T.Y. LIN INTERNATIONAL
 THE STAMPED DOCUMENTS ARE HEREBY:
 APPROVED
 APPROVED AS NOTED
 REVISE AND RESUBMIT
 SEE TRANSMITTAL FOR ADDITIONAL INFORMATION AS APPLICABLE.
 THIS REVIEW IS FOR GENERAL CONFORMANCE WITH DESIGN CONCEPT ONLY. ANY DEVIATION FROM THE PLANS OR SPECIFICATIONS NOT CLEARLY NOTED BY THE CONTRACTOR HAS NOT BEEN REVIEWED. REVIEW BY THE ENGINEER SHALL NOT RELIEVE THE CONTRACTOR OF THE CONTRACTUAL RESPONSIBILITY FOR ANY ERRORS OR DEVIATION FROM THE CONTRACT REQUIREMENTS.
 RICK HEBERT REVIEWER 2/2/2015 DATE

NO.	DATE	REMARKS	BY
REVISIONS			
		CASCO BAY STEEL STRUCTURES ONE WALLACE AVENUE SOUTH PORTLAND, ME 04106 PHONE: 207-780-6722 FAX: 207-780-6726	
STRUCTURE <u>BENMONT AVE. (TH-7) (URBAN MINOR ARTERIAL)</u>			
LOCATION <u>TOWN OF BENNINGTON, VERMONT</u>			
PROJECT NO. <u>BRIDGE NO. 57 PROJECT NO. BRF 1000(16)</u>			
ENGINEER <u>STATE OF VERMONT AGENCY OF TRANSPORTATION</u>			
CUSTOMER <u>ALPINE CONSTRUCTION</u>			
ITEM <u>GIRDER ~ 1G1A</u>			
SURFACE PREP. <u>SSPC-SP10</u> OPEN HOLES <u>1/2" (UN)</u>			
PAINT <u>NONE</u>			
APPROVAL	DRAWN <u>GDC</u>	12-5-14	SHEET NO. <u>1AB</u>
SHOP	CHECKED <u>FM</u>	1-3-15	JOB NO. <u>605</u>

- ONE ~ GIRDER ~ 1G1A**
- FOR GIRDER STANDARD DETAILS, SEE SHT. X2.
 - FOR WEB CUTTING DIAGRAM, SEE SHT. C1.
 - FOR FLANGE CUTTING DIAGRAMS, SEE SHT. C1.
 - FOR GENERAL NOTES, SEE SHT. GN1.
 - "BRG. AREA" INDICATES AREA THAT MUST BE FLAT TO PROVIDE A UNIFORM EVEN CONTACT WITH SOLE PLATE.

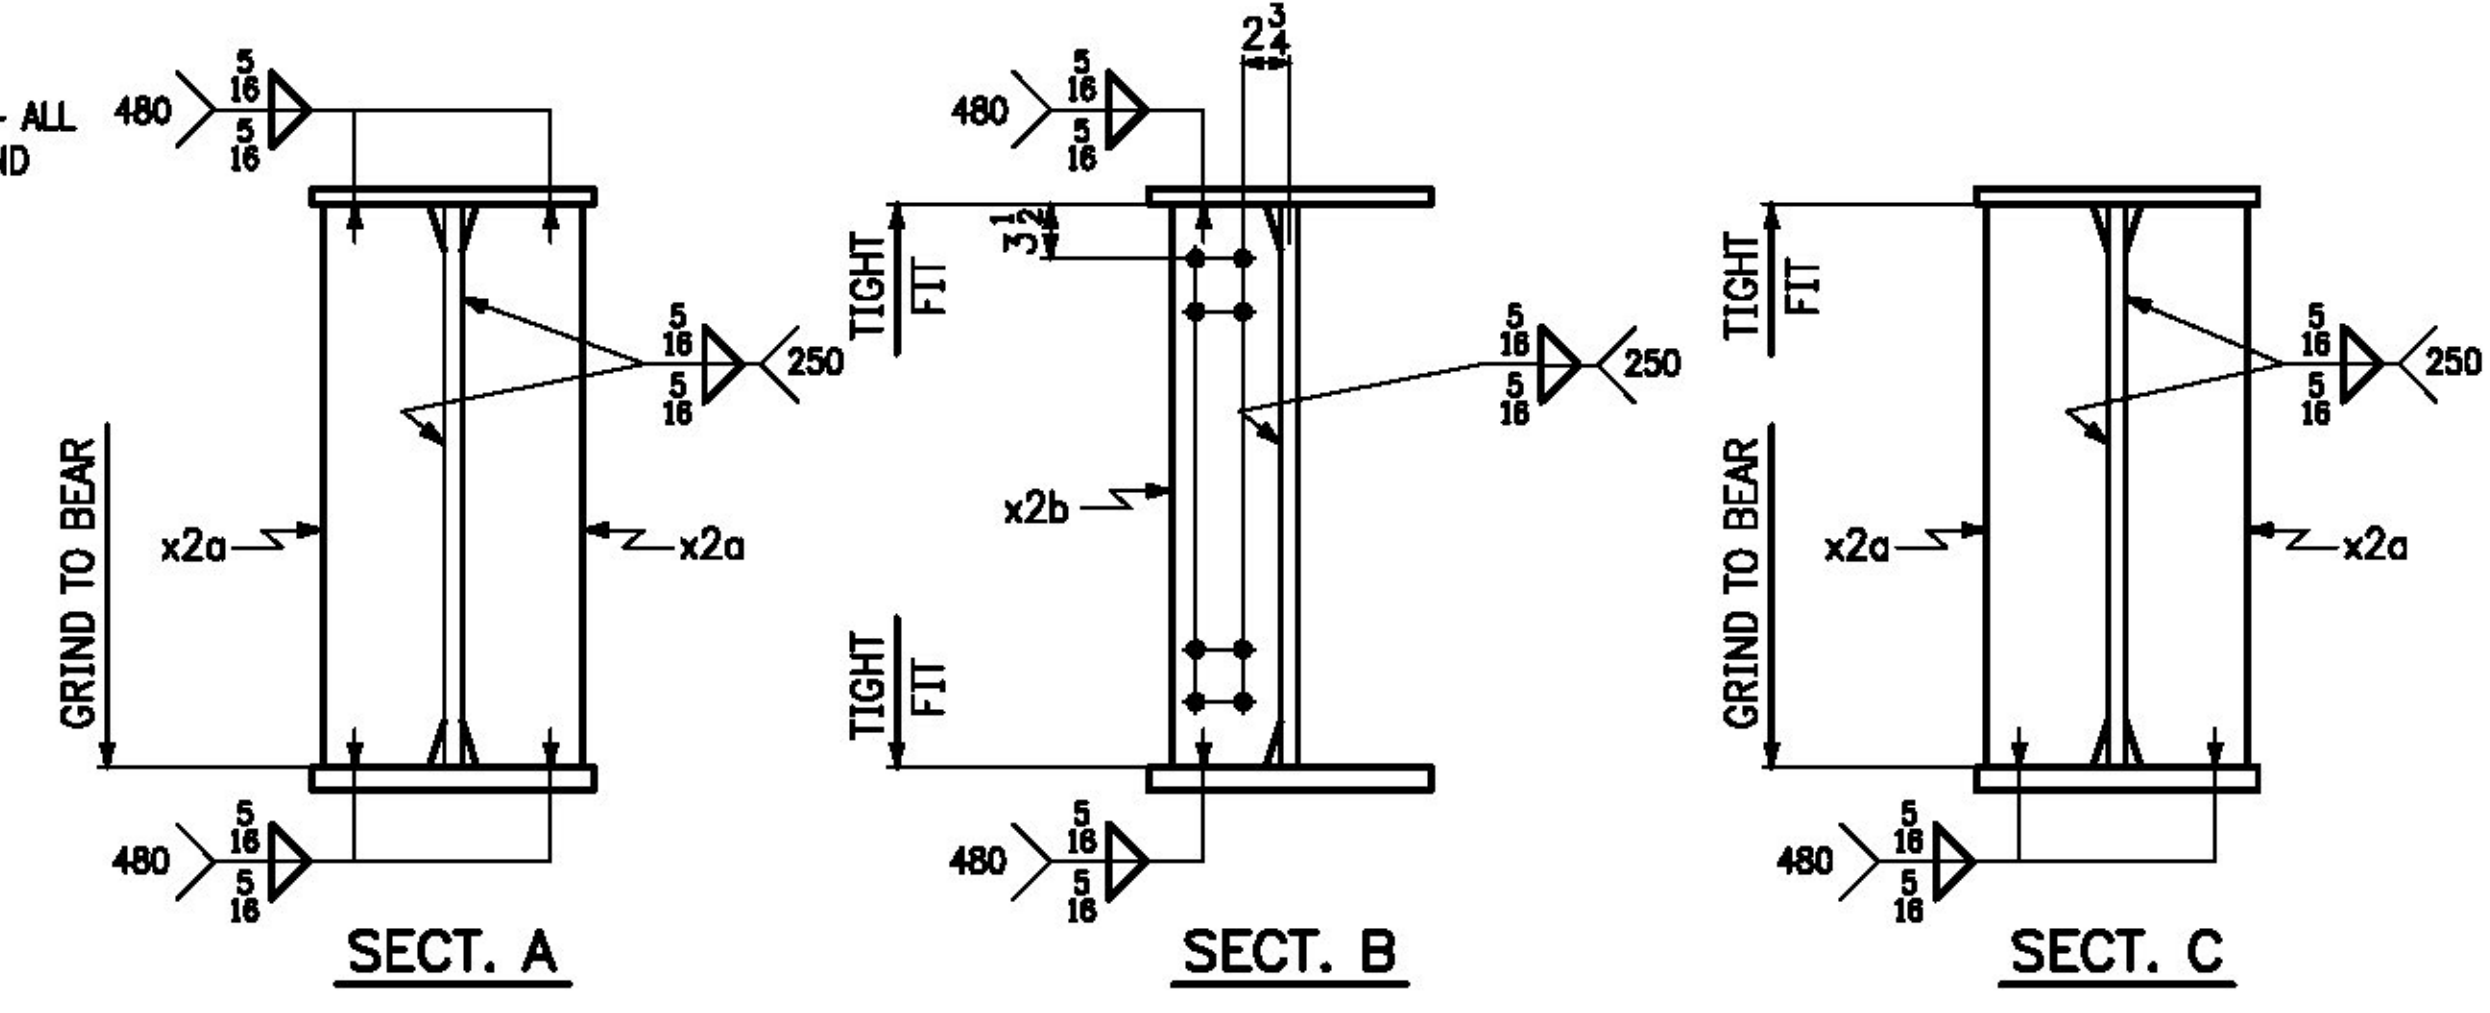
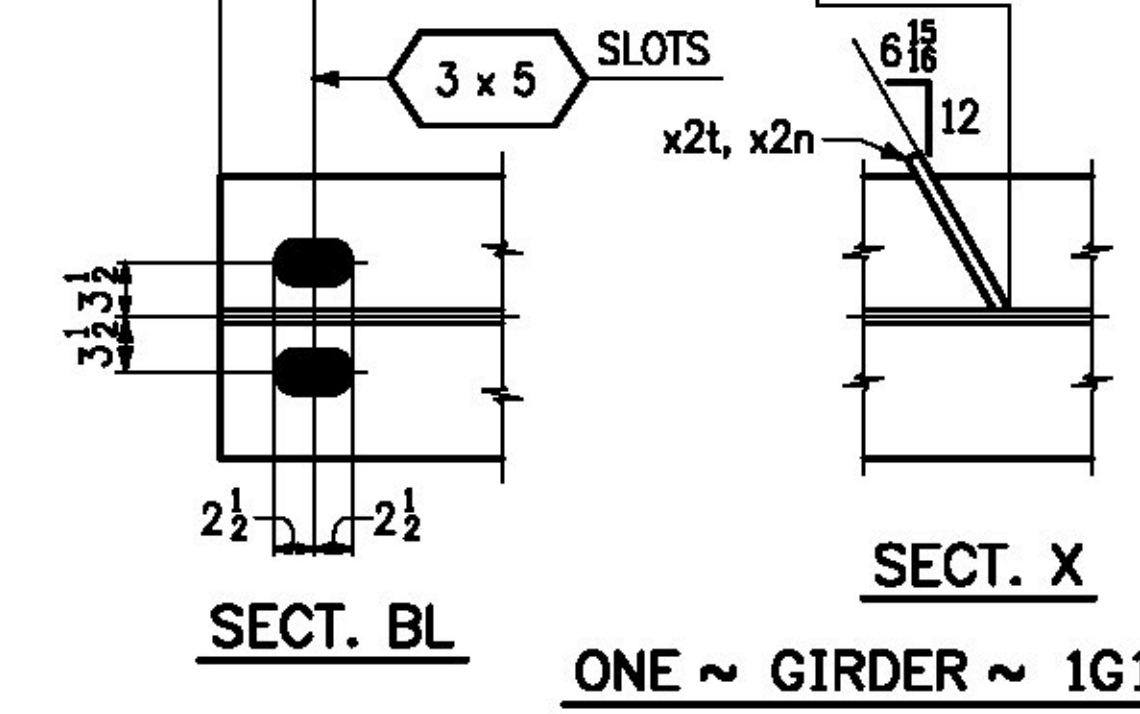
Spacing of waterline support beams are not all at 9'-0" spaces as shown on Contract Drawing Sheet 39 of 75. Maximum variation appears to be 9". The increase in span is acceptable, however the Contractor should refer to the Special Provision (Water Main on Bridge) to ensure compliance with the hanger distance to pipe joint requirements are also met.
